DFCM SOLICITATION ADDENDUM COVER PAGE

DFCM Addendum No.#003

Date: January 5, 2024
To: BIDDING CONTRACTORS
From: BRANDON ANDERSEN- DFCM PROJECT MANAGER
Reference: JORDANELLE STATE PARK DOCK REPLACEMENT
DFCM Project #23481510

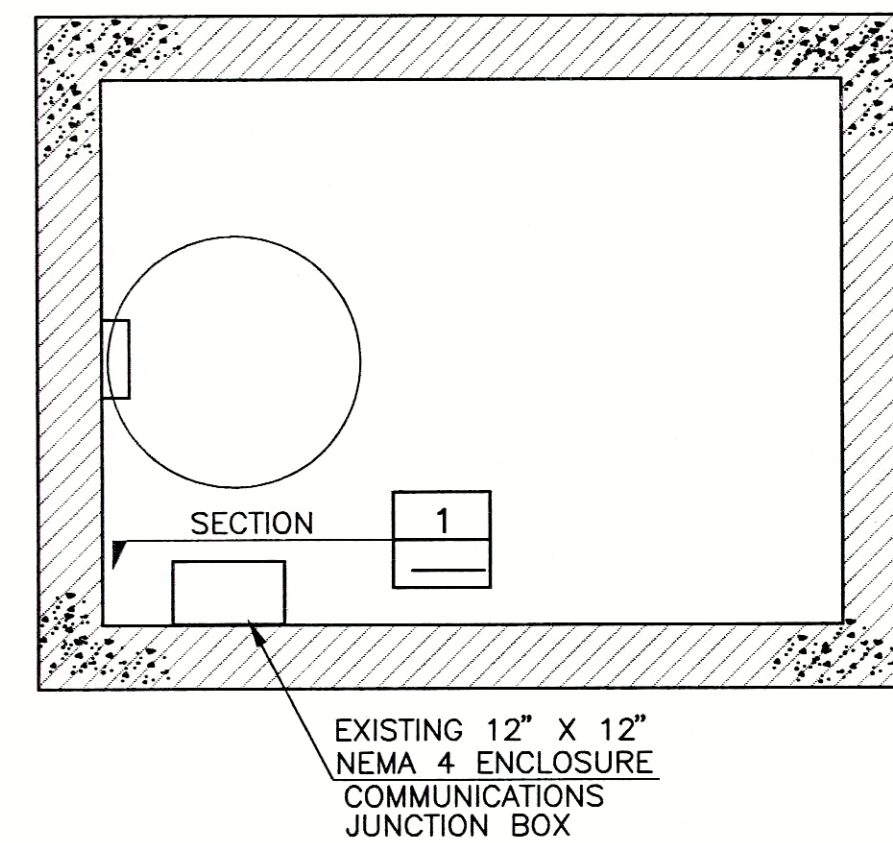
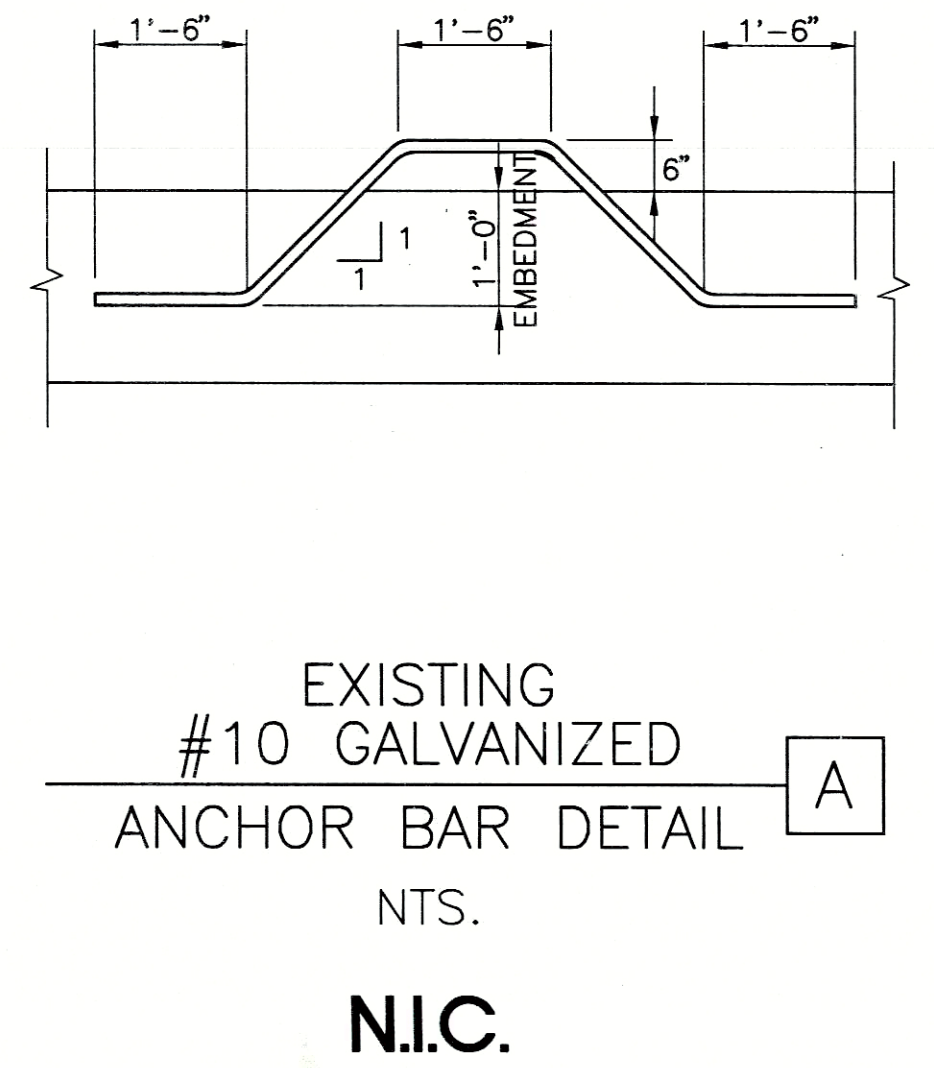
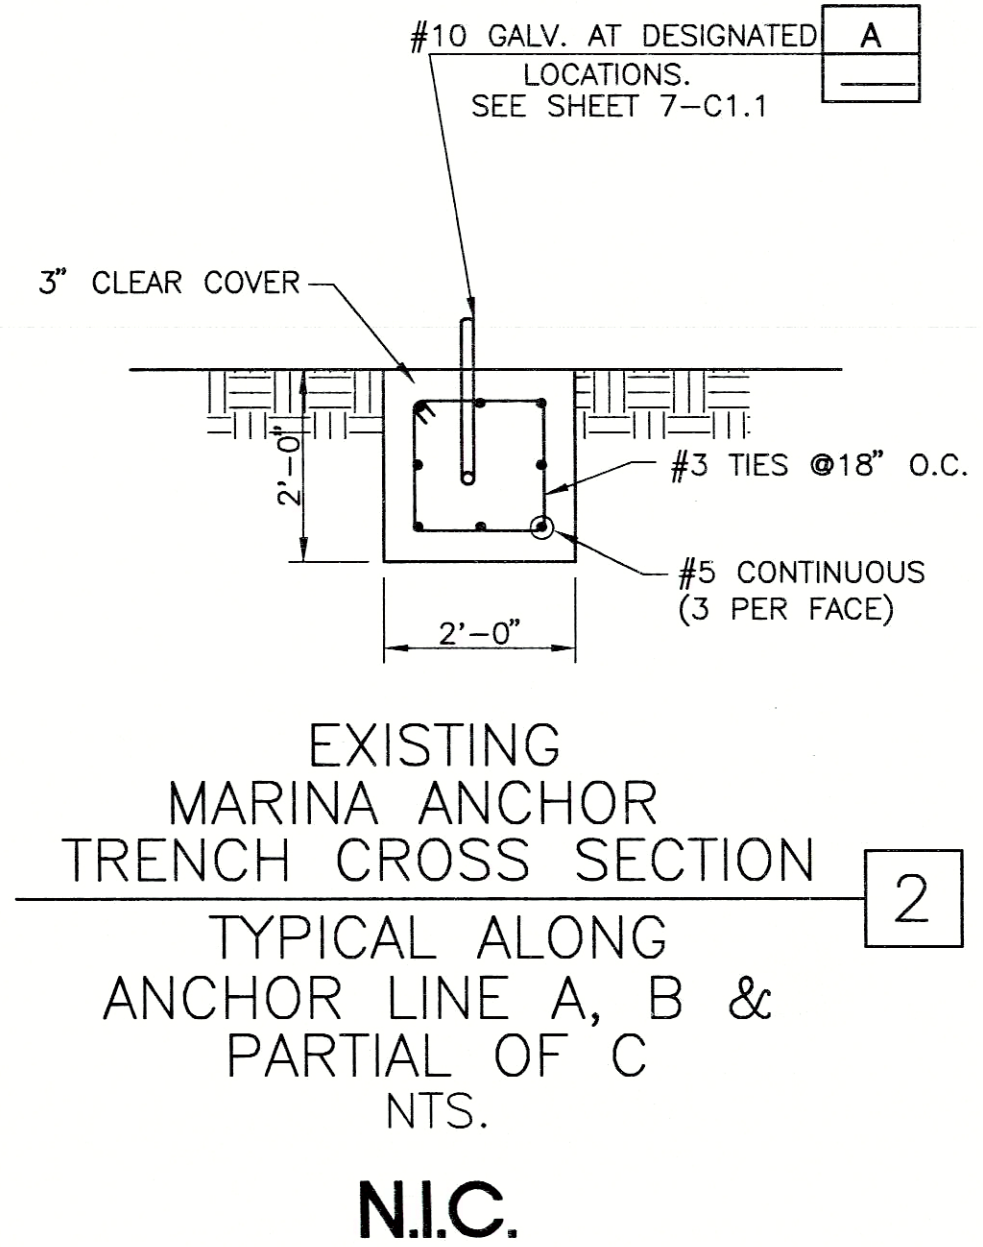
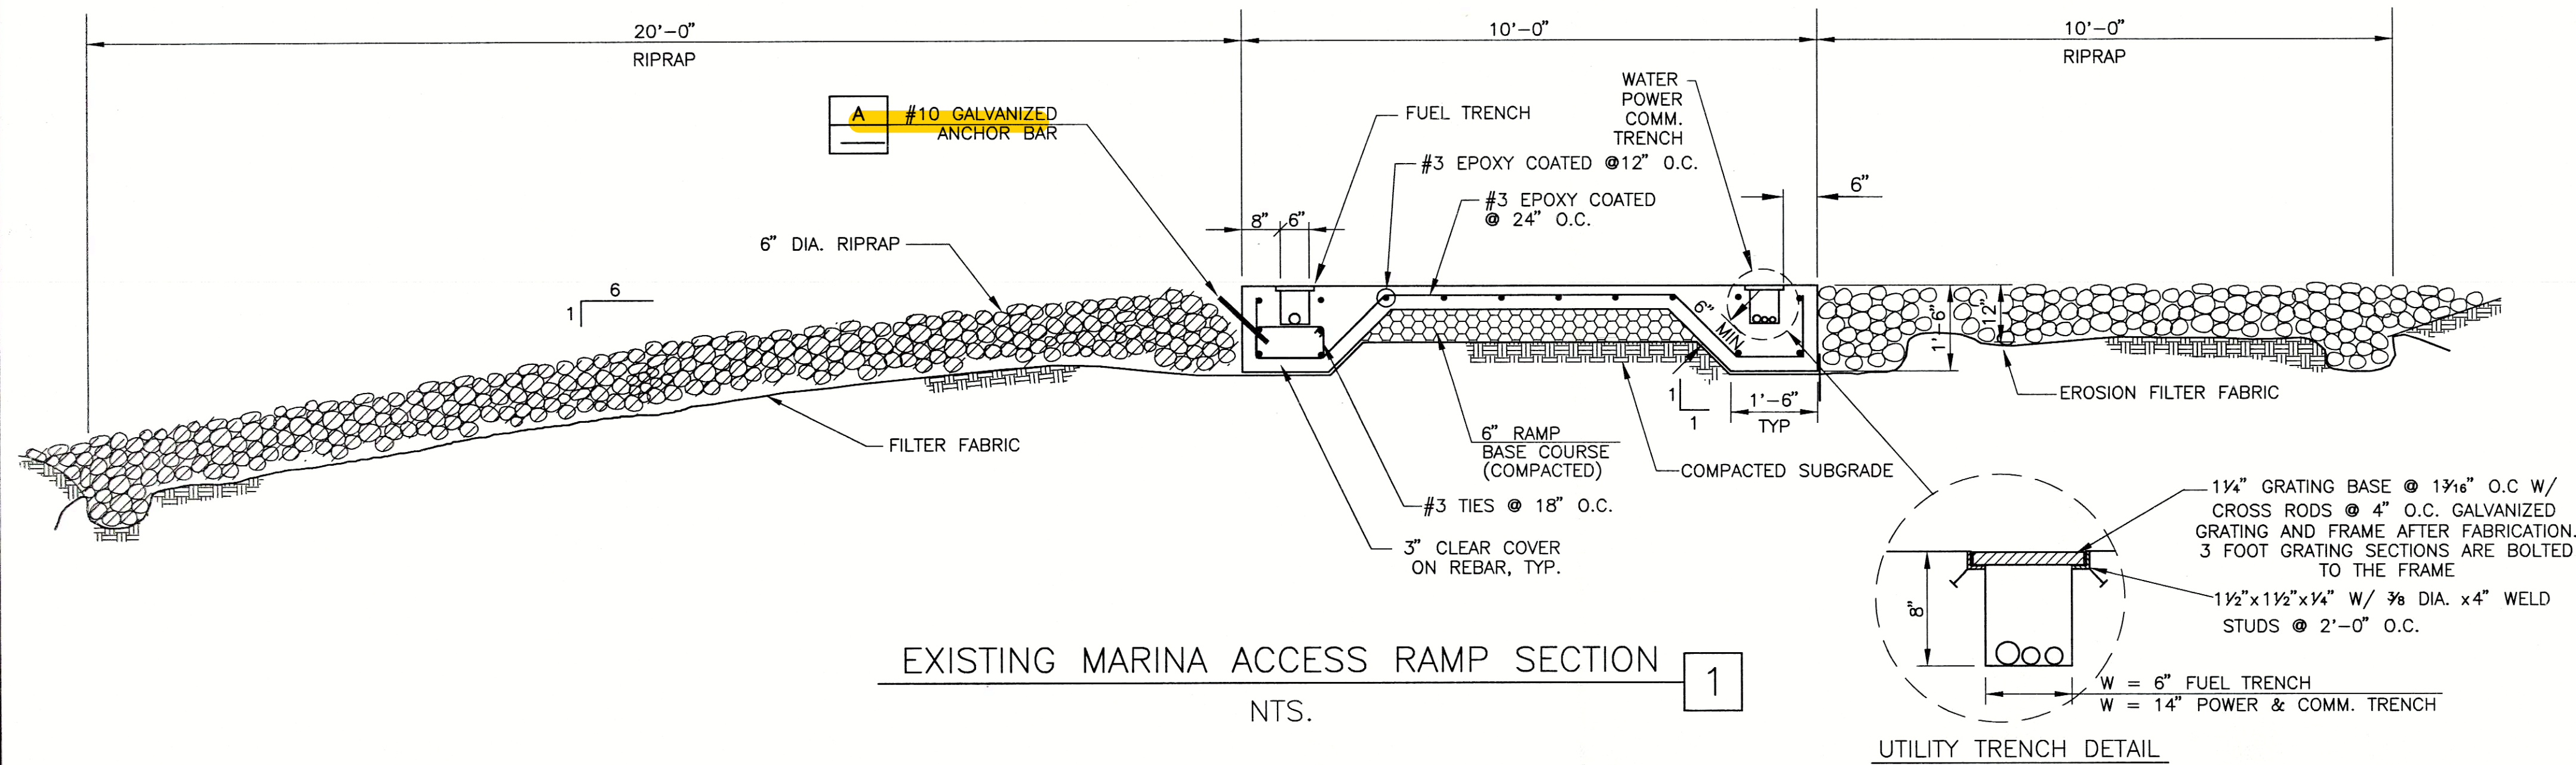
Q: The first dock is calling out two different widths on the end finger pier (southwest dock as you are looking at the paper). Please clarify width.

Q: What dimension are the corner walks?

A: 3' wide finger note is a typo . . . the Conceptual Design calls for 4' wide End Fingers on all docks

A: Conceptual Design illustrates 3'x3' corner gussets / walks – Actual proposed dock design is at the discretion, as needed, by the dock manufacturer to provide a strong and durable dock system, but given the design dock slip dimensions a 3'x3' corner would be optimal.

DFCM PROJECT NO.	NP-90-270
LOCAL PROJECT NO.	5-91009
SHEET NO.	7-C4.1
SCALE	NONE

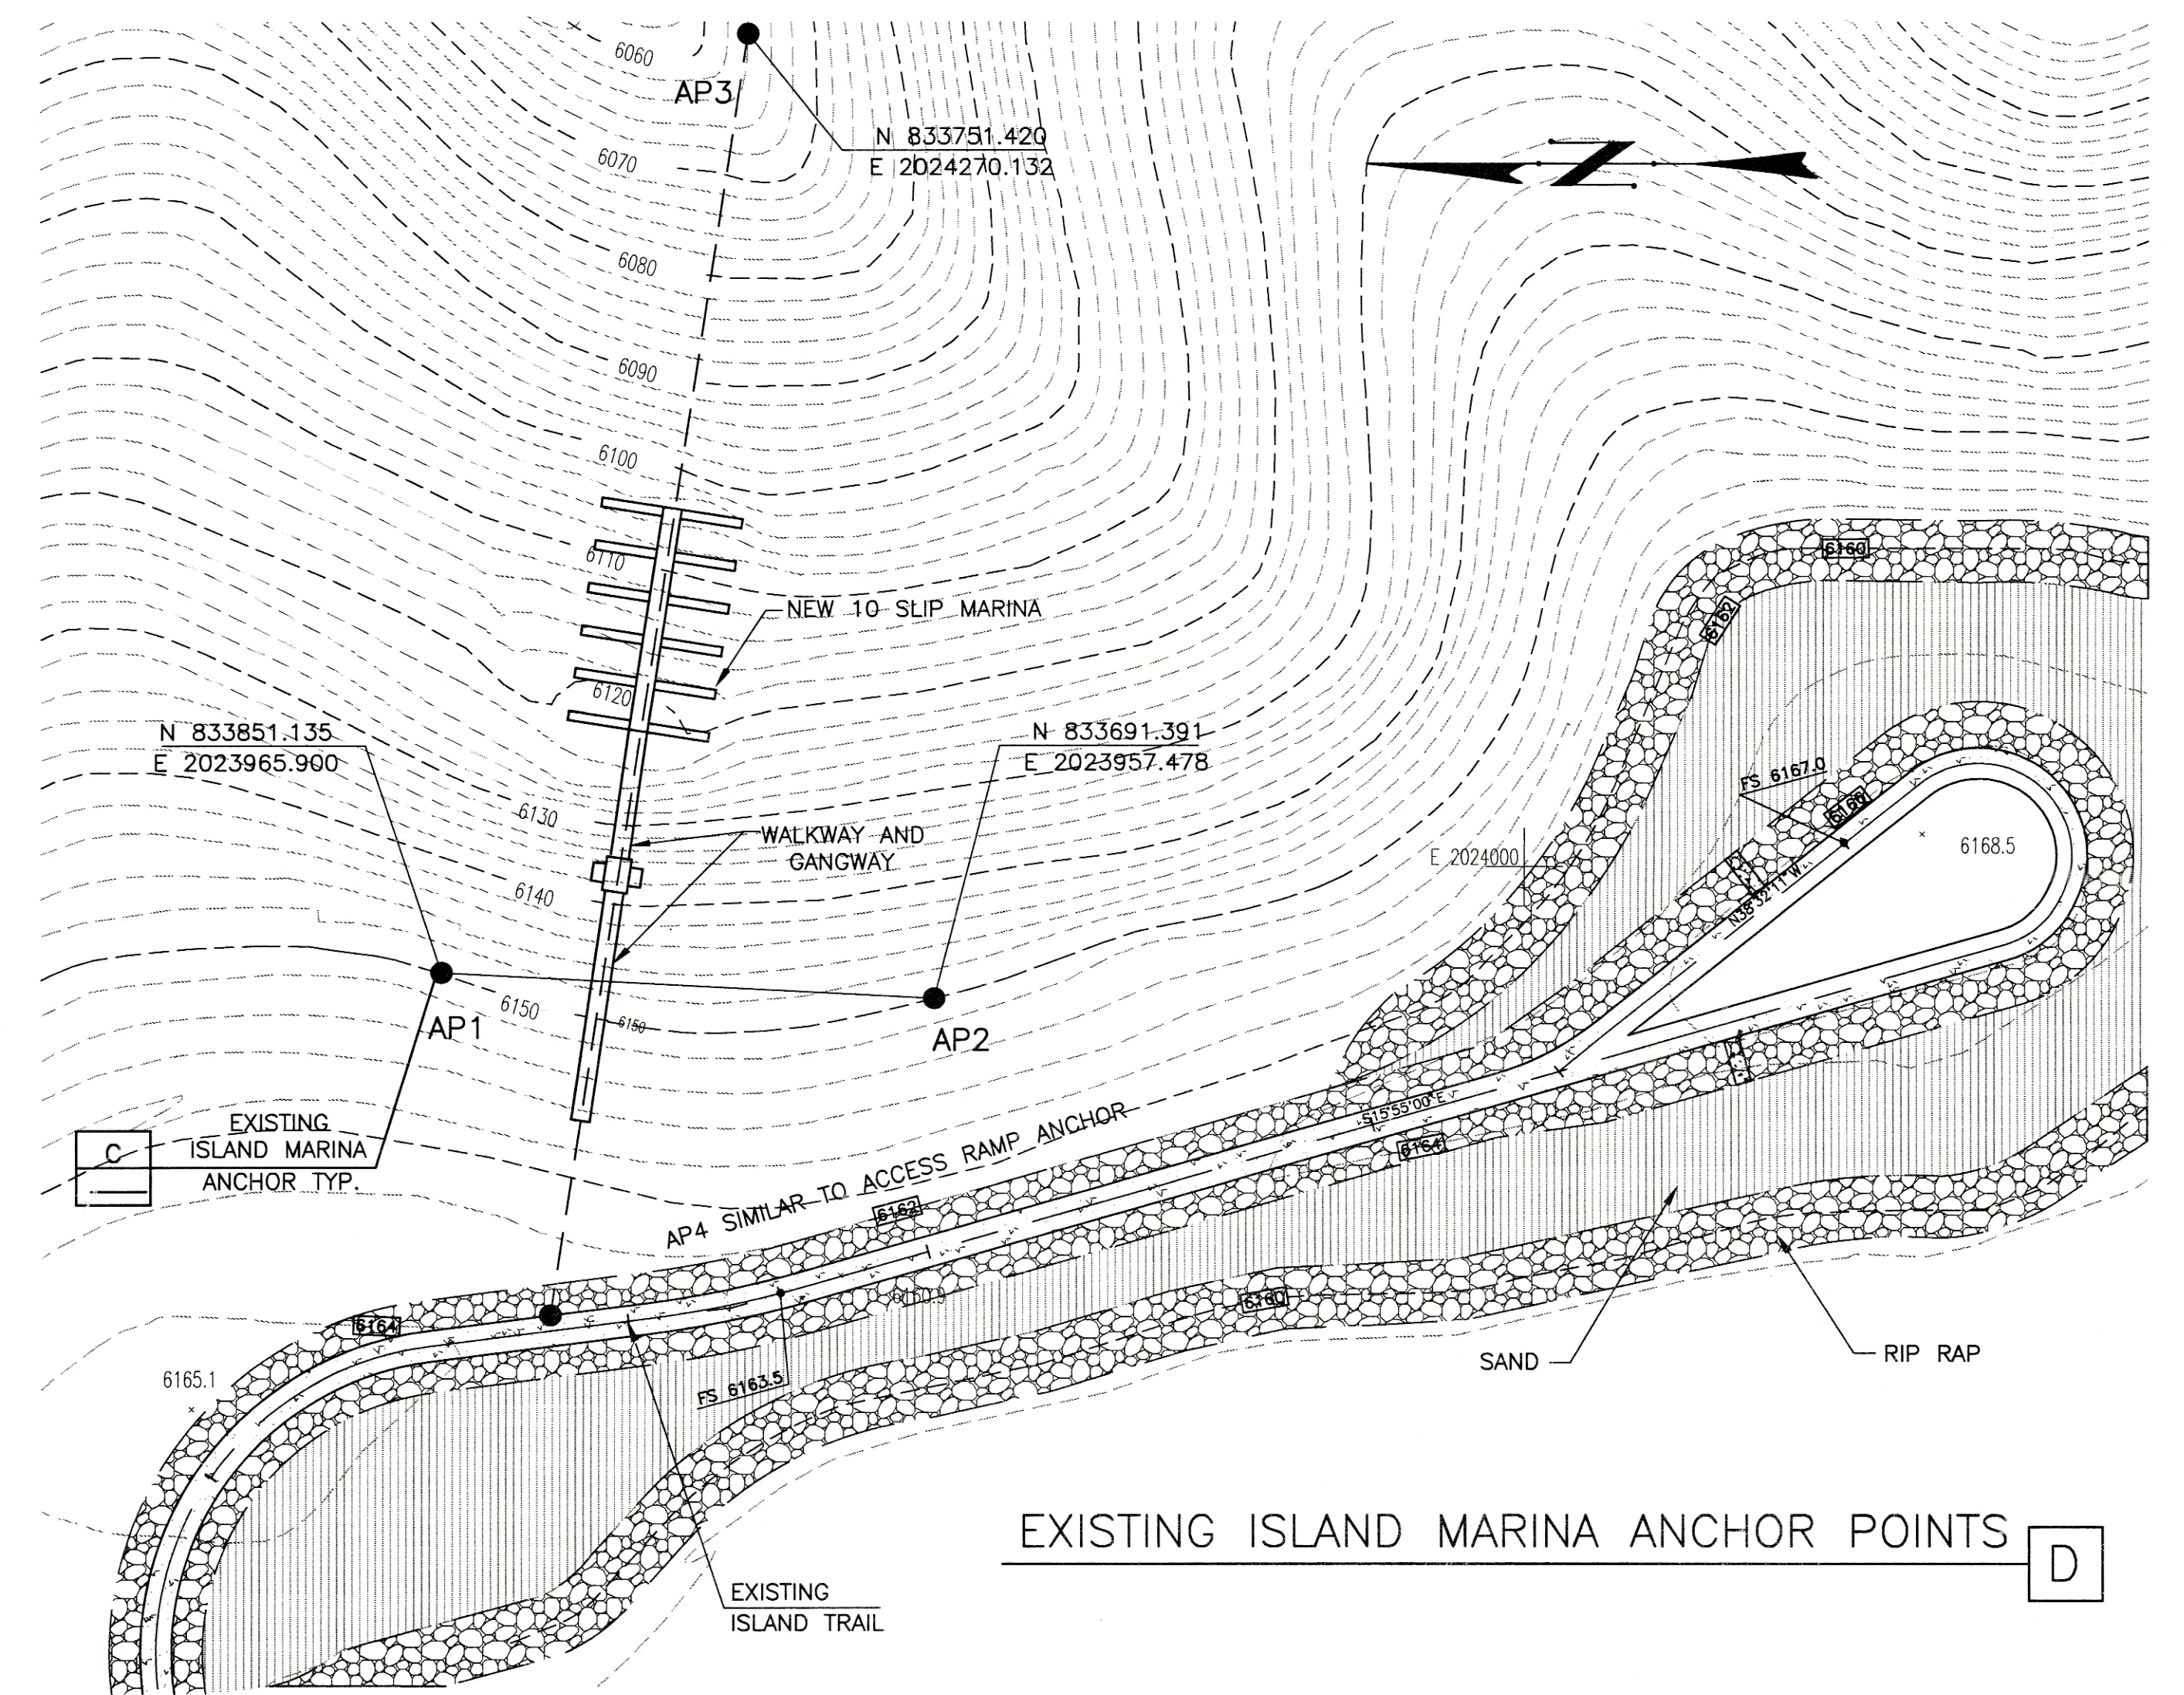
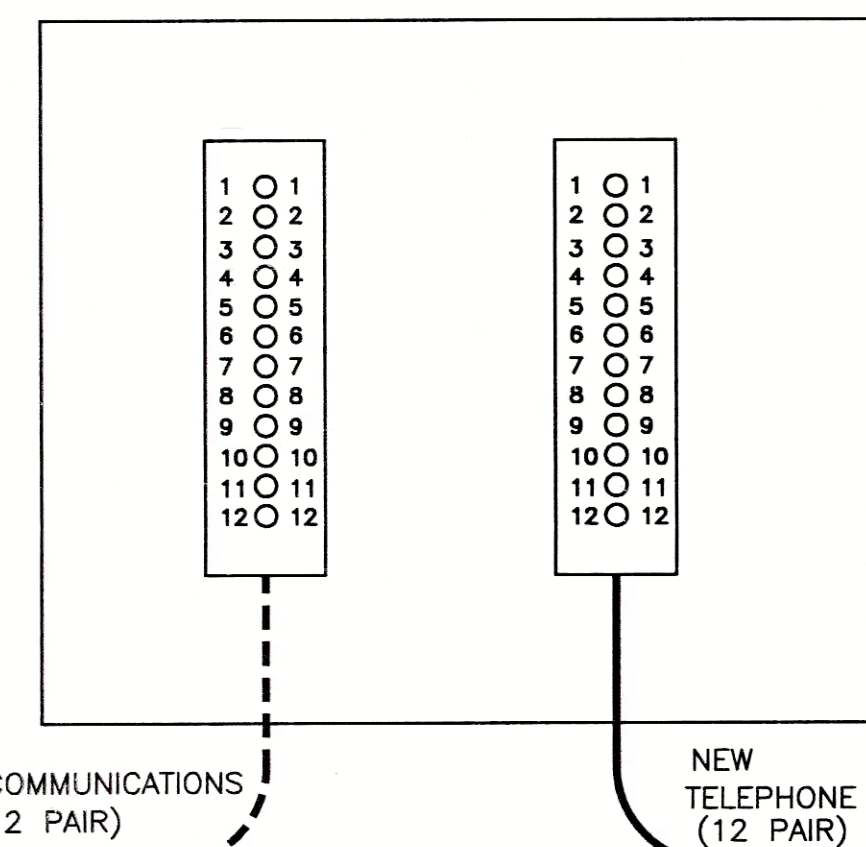
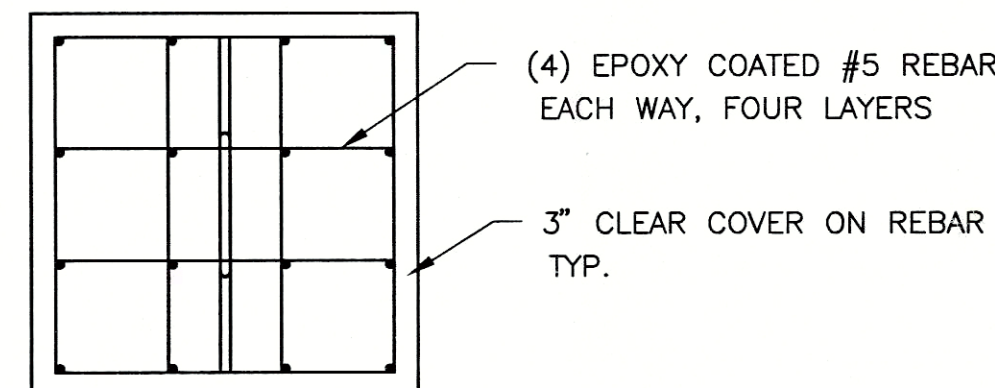
- Can we have the existing drawings shown on page 3 of the "MBA – Jordanelle SPM Design Criteria w/ Photos v072522"? If not, what is the elevation of the existing electrical panel? **The only power concerns for this contract are for the marina and the bridge. No land utilities will need to be provided just the quick connections points described in the plan.**
